Service Craftsman News

No. 11 S-278

December, 1955

4-BARREL CARBURETOR CHANGES

Fig. 1 Comparison of First and Second Type Rochester 4-Jet Choke Pistons

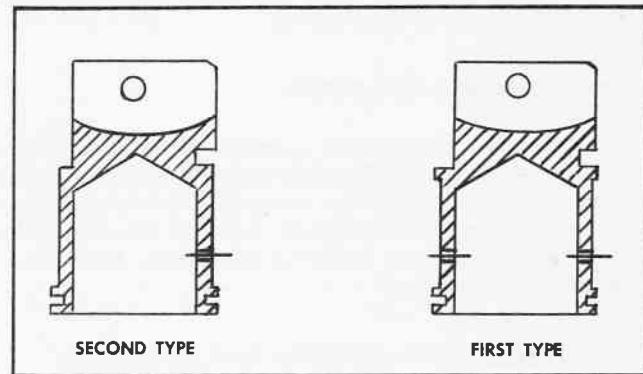
The Rochester 4-Jet change consists of a new choke piston. A comparison of this new piston and the earlier type shows that the new piston has only two lands and one hole as compared to three lands and two holes found on the first type. Fig. 1 gives a comparison of the two pistons.

The new piston is released for service under part number 7009710. When installing the new piston set the choke to one notch rich as was covered in the "November News."

Fig. 7 Right Lift Gate Support - 1955
Safari Shown

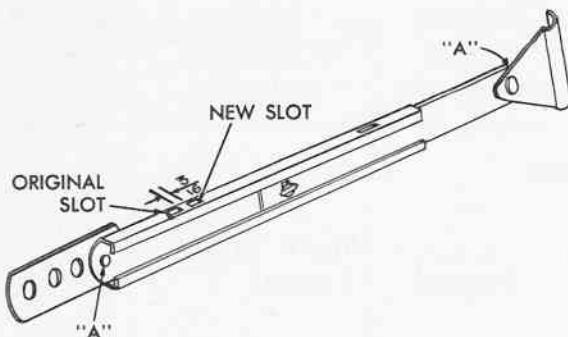
2. Remove right lift gate support on all models.
3. At a distance 3/16" above the original slot in the support used for locking the lift gate in the open (horizontal) position, make an additional slot of the same size. See Fig. 7. The use of this new slot in the right lift gate support when locking the lift gate in the horizontal position will eliminate any looseness between the inner and outer channels of the supports. Slot can be made as follows:

Fig. 8 Location of Slots on First and Second Type Lift Gate Support

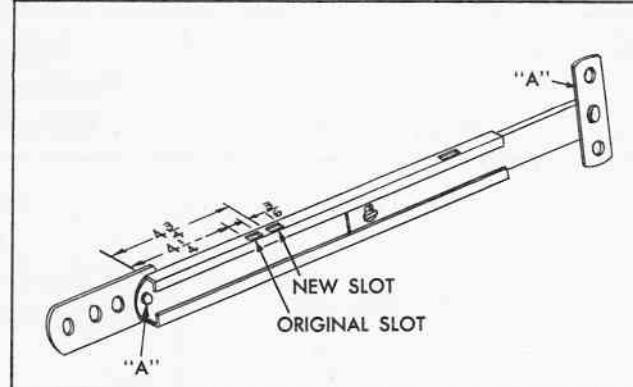
1. Check the lift gate hinges on all models except the Safari to determine whether they are the latest type. The latest type hinge has the shoulder bushing and spring supports which contact the male hinge arm to restrict side movement of the arm.
2. If lift gate hinges are not latest type, replace them with revised lift gate hinge assemblies having shoulder bushings and spring supports (Part No. 4649346-7).
3. Check the right lift gate support on all models to determine whether it is the latest type. The latest type support has the horizontal position locking slot located 4-3/4" from the lift gate end of the channel. On the first type support the horizontal position locking slot is located 4-1/4" from lift gate end of channel. See Fig. 8.
4. If lift gate support is not the latest type, rework supports as described previously for 1955 styles in steps 2 through 8.

Fig. 9 Station Wagon Drip Moulding Area

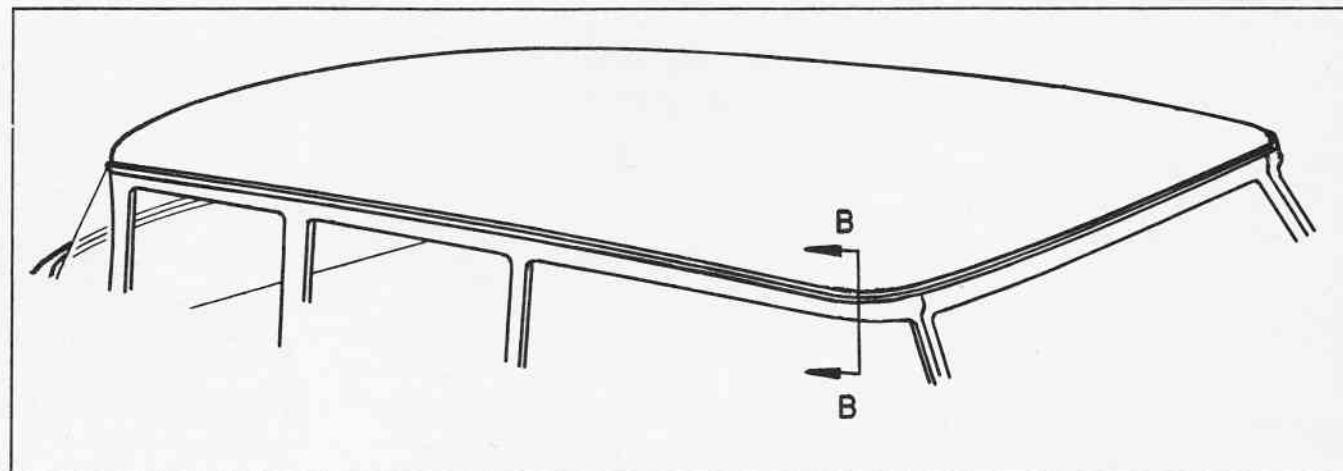
Several reports have been received regarding paint failure at the joint between the roof drip moulding and the upper rear quarter panel on station wagon models. Following is a suggested repair procedure for this condition:

1. Remove paint and rust thoroughly to bright metal finish.
2. Apply thin coat of neoprene weatherstrip cement at point "A" (Fig. 9).
3. Dry to hard surface (approximately 3 hours).
4. Repaint and refinish.
5. Check joint at point "C" (Fig. 10) and reseal if necessary.

Fig. 11 Convertible Top Water Wicking Repair

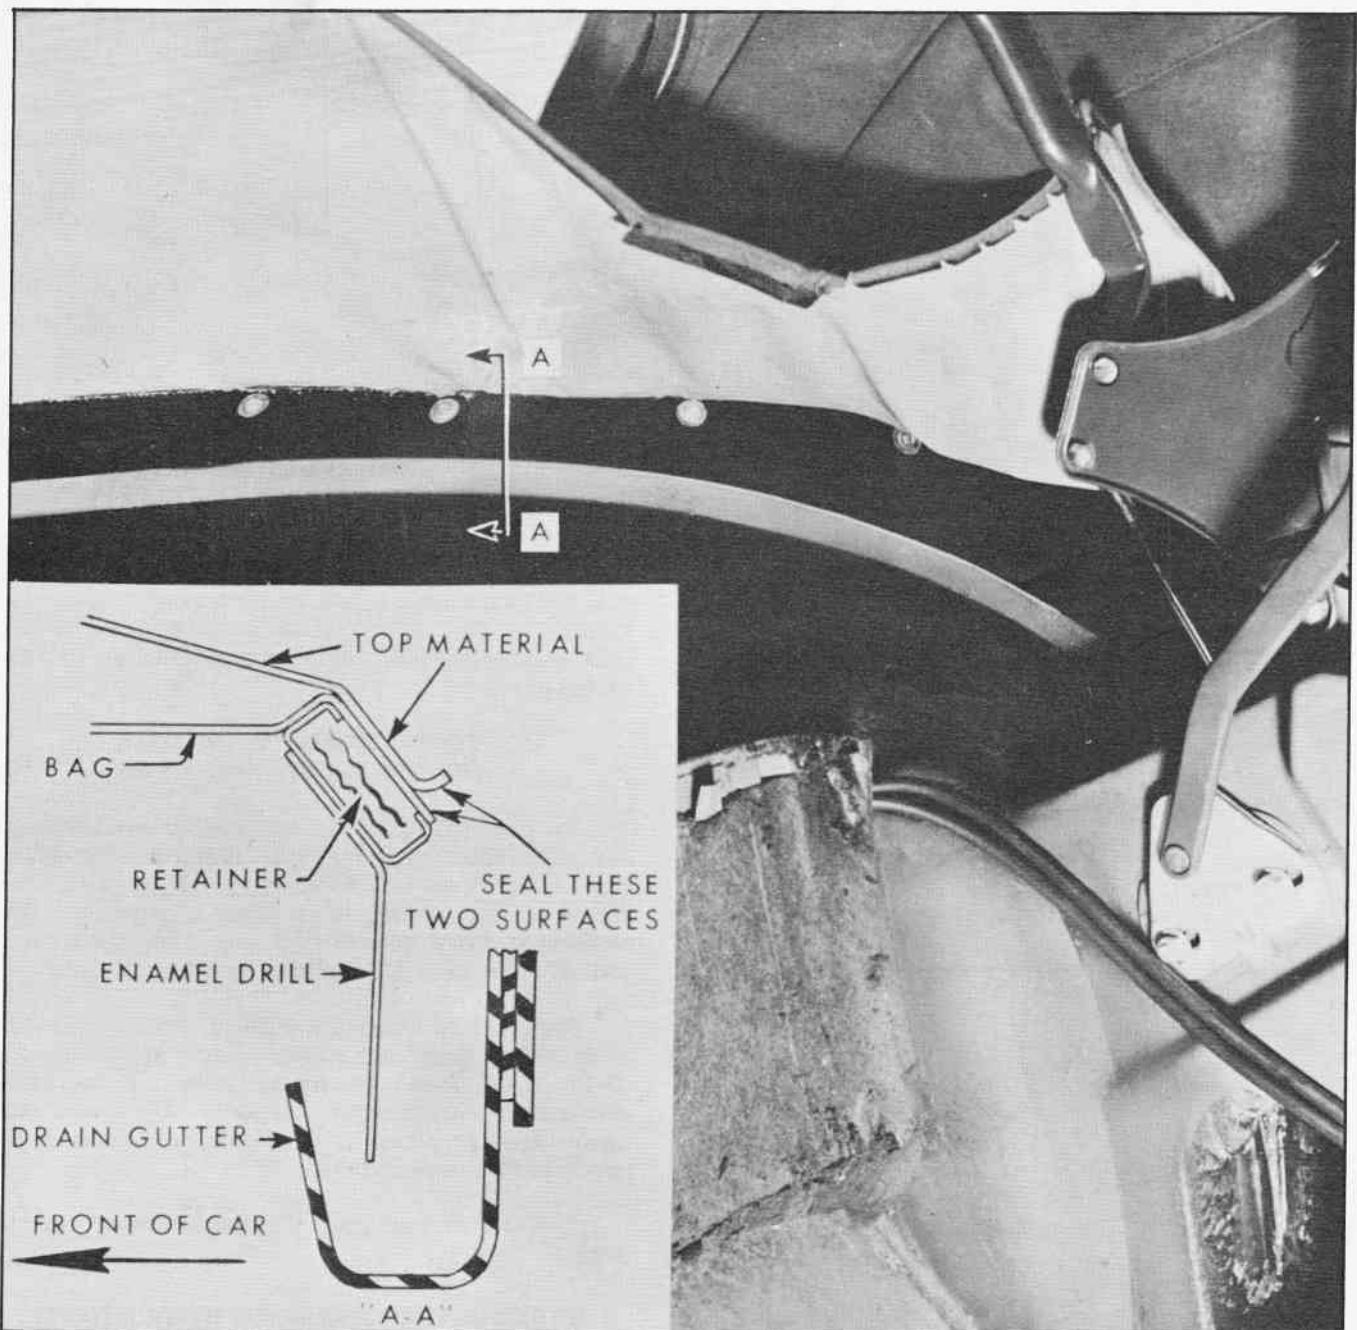
If water wicking is encountered at the folding-top compartment bag or at the inner surface of the folding top material along the back and/or rear quarter belt lines, the edges of the bag and top material should be sealed along the rear trim stick.

3. Remove trim stick retainer attaching screws and raise bottom section of top from body.
4. If there is wicking of top material or bag, seal trimmed edges of material with an approved convertible top sealer as shown in Fig. 11. The inside surface of the top material should be waterproofed along entire length of trimmed edge. Be sure that edges of stay pad along retainer are thoroughly sealed.

5. a. If water overshoots gutter below bottom edge of folding top, cement cotton side of a piece of enamel drill to inside (metal) surface of retainers with an approved weatherstrip cement. The top edge of enamel drill should not extend above top edge of retainers and should be of sufficient width to extend into gutter for entire length of gutter. (See step "c" and see Fig. 11.)

Fig. 12 Over Staked Flywheel Housing Bushing

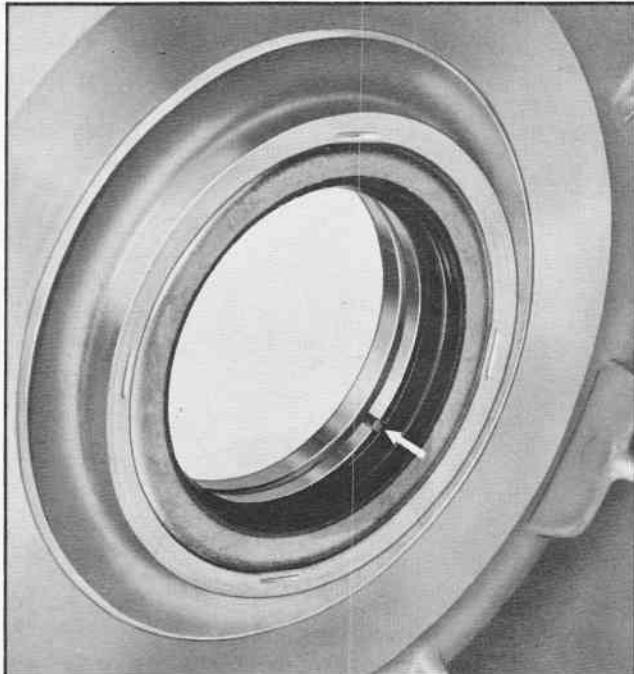
Some cases have been found where the Flywheel Housing Bushing on the Strato-Flight Transmission has been overstaked causing grooves as shown in Fig. 12. The grooves run between the four normal staking marks and the circular lubrication channel.

These grooves may be the cause of torus drain back or front seal leak. If disassembly for one of the above conditions or any other condition is necessary, the Flywheel Housing Bushing should be inspected for these grooves. In all cases where the grooves are present the Flywheel Housing Assembly should be replaced.

Fig. 13 Left Hand Front Tail Pipe Support Installed

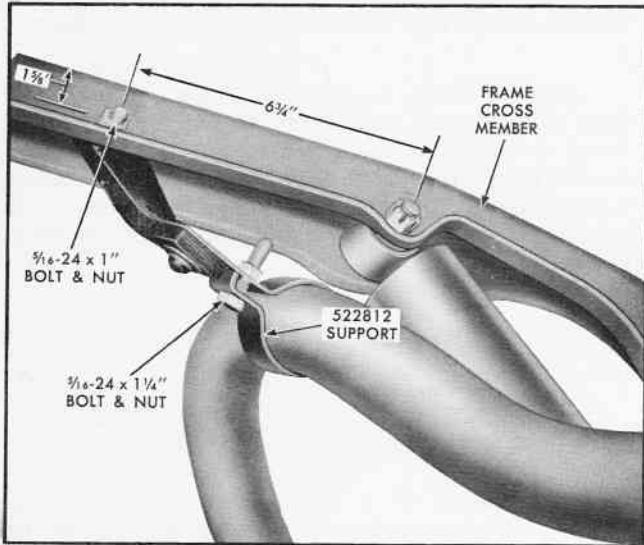
Due to the Product Information Reports received on tail pipe rattle on dual exhaust equipped cars a front tail pipe support assembly is now in production and is available for service under part number 522812 as a master warehouse item.

The tail pipe support should be installed, as shown in Fig. 13, on any cars which have an objectionable rattle. It is necessary to drill one hole as located in Fig. 13 using an 11/32" drill.

Fig. 14 Neutral Clutch Drum Chamfer

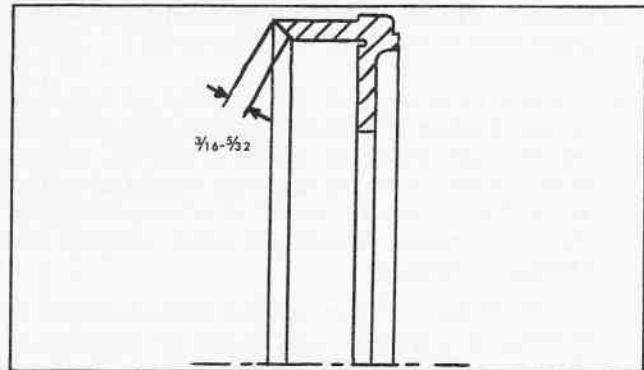
The drum must have a 5/32" - 3/16" width chamfer measured across chamfered surface on the inside leading edge (Fig. 14). If chamfer is less than 5/32", the drum should be replaced.

Fig. 15 Location of Grooves in Neutral Clutch Drive Plates

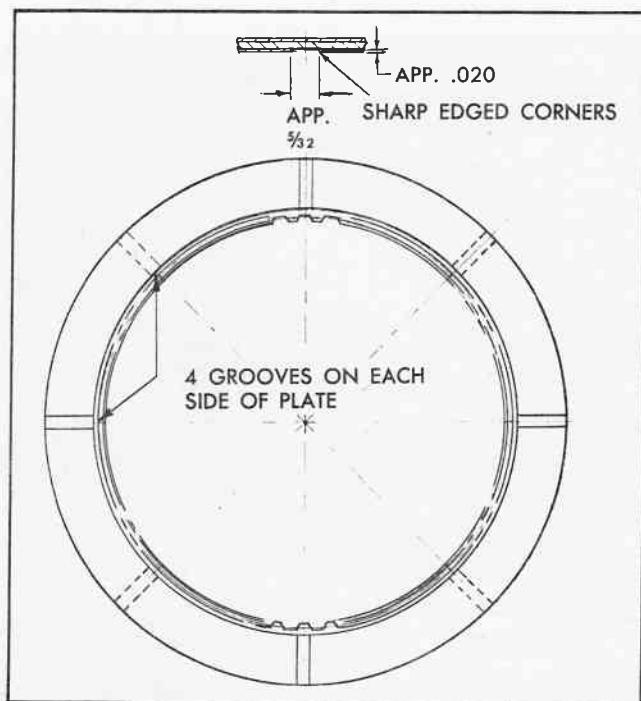
Undamaged neutral clutch drive plates can be reused and durability increased by slotting. Cut four radial, equally spaced, sharp-edged grooves on each side of the cork facings on the Neutral clutch drive plates. These grooves must be 1/8" to 5/32" wide and

have a depth of approximately .020. Note that grooves on one face are spaced between grooves on other face (Fig. 15). Use a square-cornered (mill) file to perform this modification. Any new plates in stock if not slotted must be slotted before use.

Fig. 16 Point of Clearance Check - Front Pump Bushing and Torus Shaft

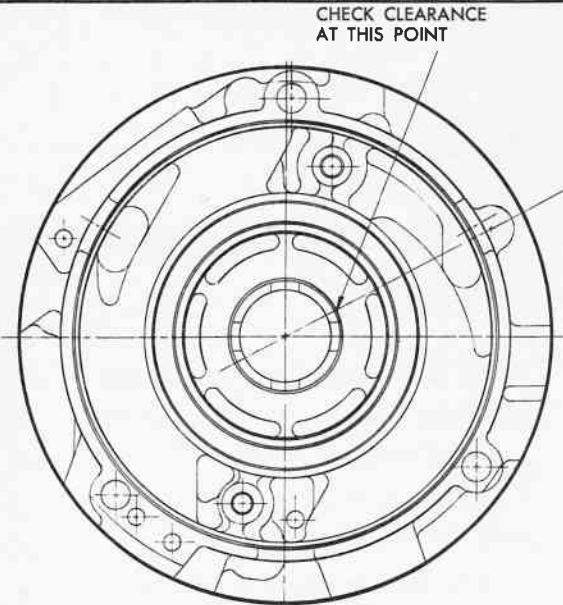
The clearance between front unit driven torus shaft and front pump bushing must not exceed .003" using a 1/2" feeler gauge at point shown in Fig. 16. The measurement must be taken at the point shown since this is the point of greatest thrust. If a .004"

gauge can be inserted between the front unit driven torus shaft and the front pump bushing, the front pump and front unit driven torus member should be replaced.

Fig. 17 Spacer Plate Modification

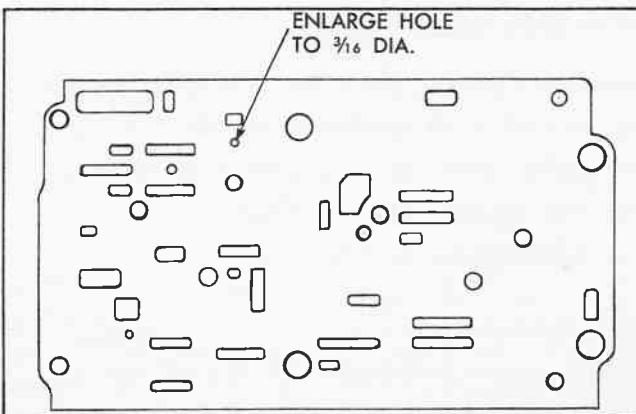
Anytime the control valve assembly is removed from the transmission the neutral clutch feed passage in the spacer plate should be drilled to 3/16" (Fig. 17).

Fig. 18 Front Sprag Inner Race Identification

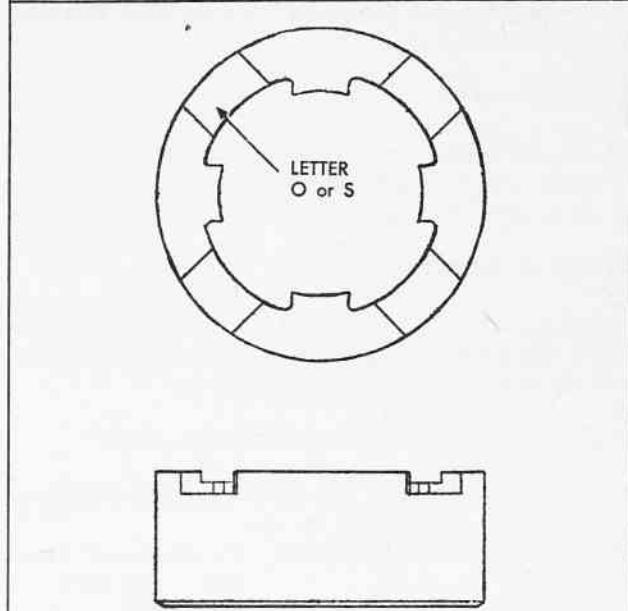
If the inner race is not of the late type, which can be identified by an "O" or "S" in the recess of the tang end, it should be replaced (see Fig. 18).
